20-24 Pope's Road, Brixton

Planning application no. 20/01347/FUL

Planning application

Demolition of existing building and erection of part 5, part 9 and part 20-storey building with flexible A1 (shops)/ A3 (restaurants and cafes) / B1 (business) / D1 (non-residential institutions) / D2 (assembly and leisure) uses at basement, ground floor and first floor levels, with restaurant (Class A3) use at eighth floor level and business accommodation (Class B1) at second to nineteenth floor levels, with plant enclosures at roof level and associated cycle parking, servicing and enabling works.

Figures 7a and 7b – Originally proposed (left) and currently proposed (right) structural cross bracing [Image from DAS addendum September 2020].

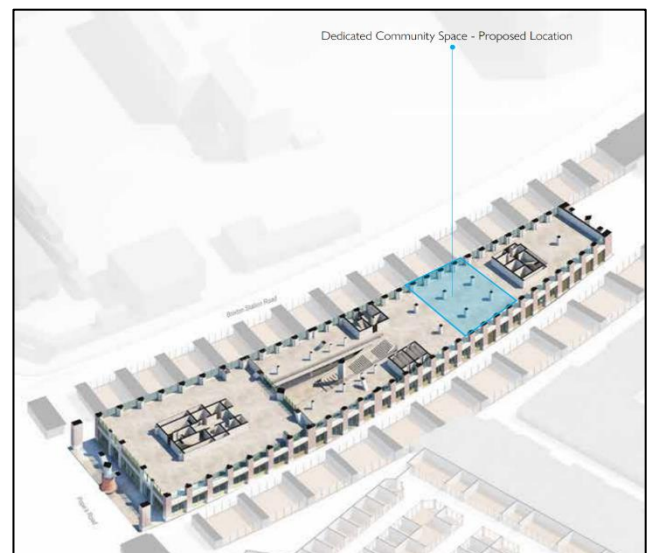
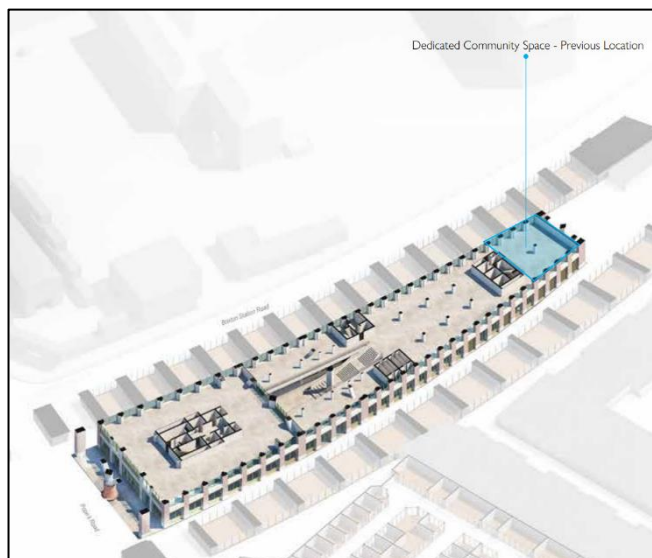
- Raising the structural cross bracing at ground level to enable the creation of a central feature seat adjacent to the new building entrance (Figures 7a-b)
- Lightening the colour of the concrete elements on the façade (Figures 7a-b)
- Reducing the breadth of the horizontal feature beam at the top of the building on the west and east elevations (Figures 8a-b)
- Adding additional horizontal bands to each of the upper-level terraces (Figures 8a-b)
- Confirming the proposed brickwork
- Remodelling the interior of the building to locate the dedicated community floorspace in a more prominent and accessible location on the first floor (Figures 9a-b).

Figure 12 - Proposed frontage widths along Pope's Road

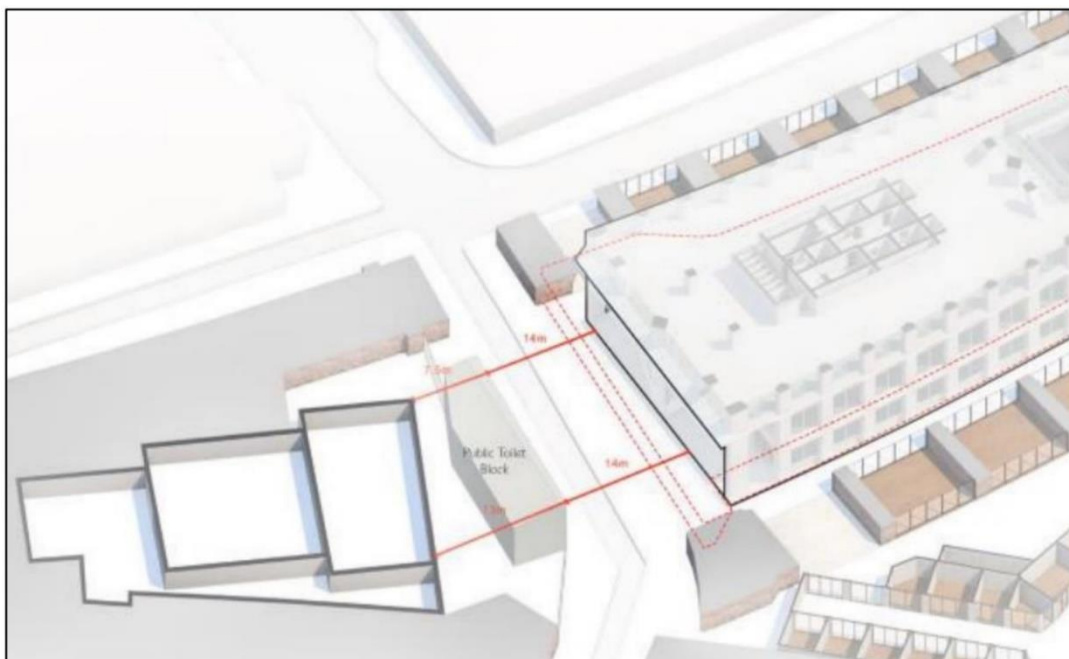
235. The ground floor of the proposed building is set back from the existing building line but the columns, supporting the floors above, project forward on a similar line to that existing. This would create a 14-metre separation distance between the proposed façade and the public toilet block across the road, and a 21-27 metre separation distance between the proposed façade and the three-storey office block opposite the site, as shown in Figure 12 below. However, as above, this does not take into account the columns which project forward from the shop frontages/entrance points of the building. The building would be set back from the viaducts to the north and south by approximate 3.7 metre on each side of the building.

236. The setback of the proposed building would be covered by a double height overhang and punctuated by structural bracing columns. The centre column would be encircled by a bench as shown in Figure 13 below. The applicant is also proposing to remove the public toilets building that is currently across the road from the application site and re-provide these facilities within the proposed development. The removal of the toilet block and frontage public realm could be secured through the s106 agreement and/or planning conditions were the scheme considered acceptable in all other respects. The primary entrances to the office stairway (eastern block), lifts to office cycle storage and the public toilets are located beneath the double-height cantilever and behind the large circular structure column. This arrangement partially obscures views of those entrances from the street and potentially any new station entrance which could come forward in the future. The columns would also reduce available public realm particularly when it's likely that significant demand will be placed on those entrance points. The main entrances to the internal retail units are more visible with clear sightlines to and from Pope's Road. These concerns regarding the frontage of the building were raised by the London Review Panel along with the GLA commissioned architect.

Figure 14 – The potential east-west routes to the side of the building shown in yellow above.

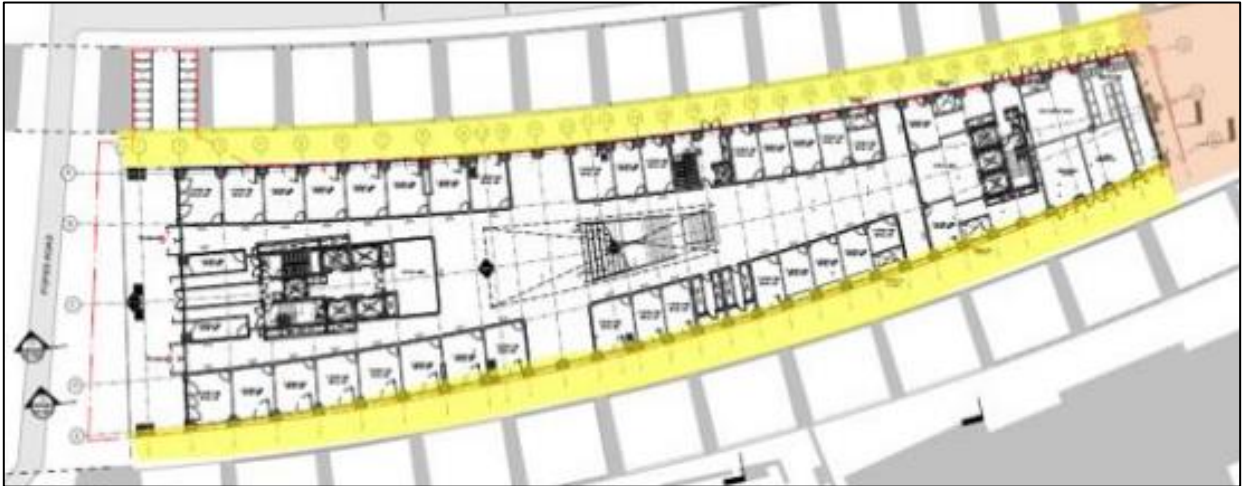
243. While the proposed drawings include ground floor shops with doors that open out onto these side routes, it has not been demonstrated how these units could feasibly and safely open out onto and be accessed from these side alleyways. Therefore, it cannot be ascertained how active, safe, useful, and overlooked these spaces would be. In addition, given the size of the retail units, it is considered unlikely that the units could function effectively with both internal and external frontages. This point and the importance of these routes were made by the Mayor's Design Advocates and Lambeth's Design Review Panel. Without evidence to say otherwise, given the ownership issues, the use of these routes cannot be secured as part of this proposal and would feel inhospitable without activation. As currently designed, these side routes cannot be considered attractive or legible.

Figure 27 - Existing (left) and proposed (right) view from Brixton Hill at Lambeth Town Hall (View 13a, dusk)

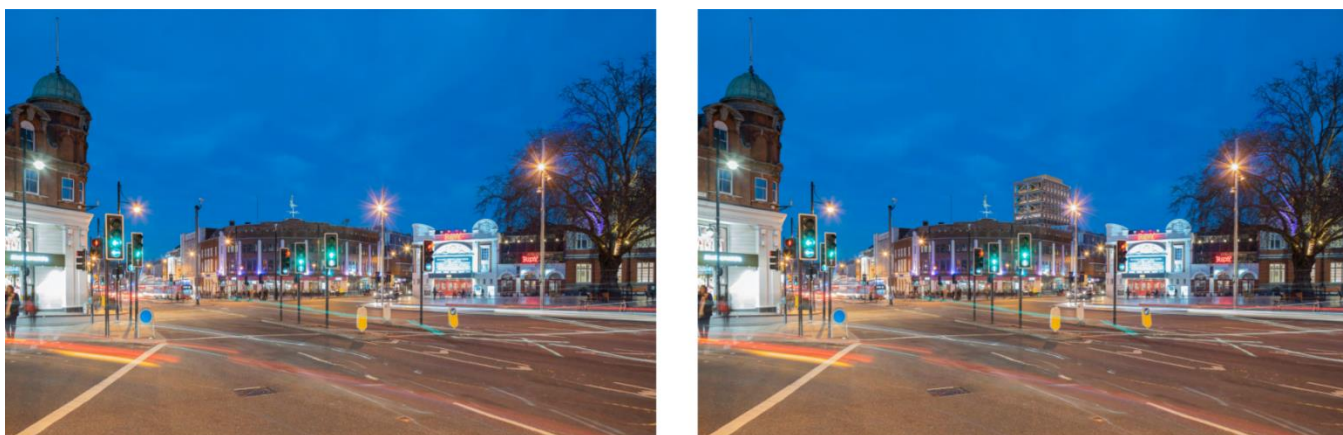
271. Views 13 and 13a (Figures 26 and 27, above) are taken from opposite Lambeth Town Hall at the northernmost part of Brixton Hill where it intersects with Acre Lane. From this vantage point the proposed building would be seen rising beyond the parapet of 467-469 Brixton Road. This is a prominent view within Brixton. The proposed height, scale and form the building would appear dominant in this context particularly noting the relatively low-rise buildings in the foreground and the curved nature of the corner building (467 Brixton Road). Following further urban design advice and greater scrutiny by GLA officers, the proposal's height and scale from this view does not make a positive contribution to the local skyline and would result in harm to the Brixton Hill / Road street scene.
